**NEEDS FOR AND ALTERNATIVES TO (NFAT)**

**La Capra Associates Undertaking # 103**

**UPDATED** Figure 3-6: Impact of Wind Cost Changes on Wind Gas minus Preferred Plan CPV

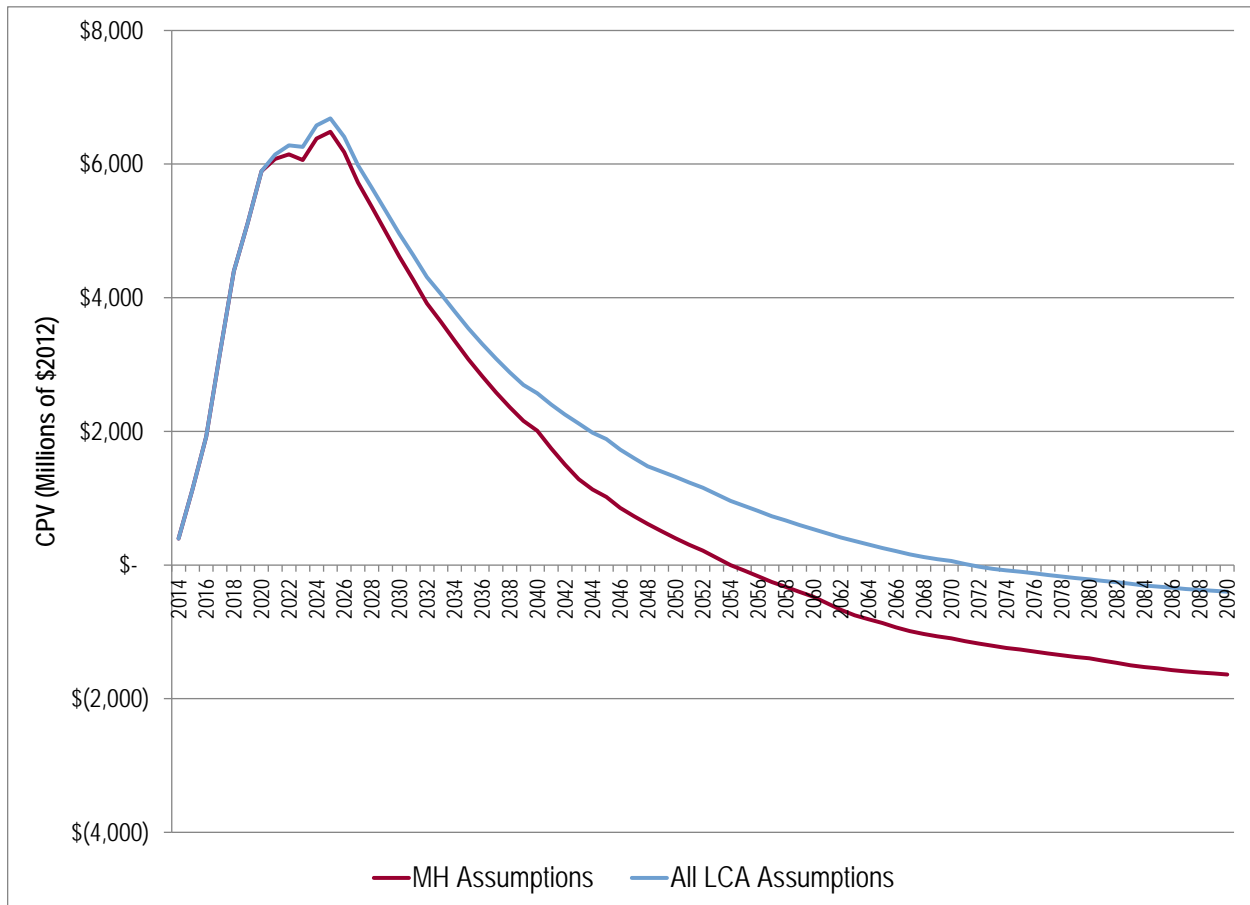
La Capra to provide updated crossover points for the Wind Case, reflecting the change in Keyyask and Conawapa capital cost

Below is a revised version of Figure 3-6 using the updated capital costs for Keyyask and Conawapa. As shown in the revised version, the crossover point for the LCA Wind/Gas Case is now 2072, fifteen years later.
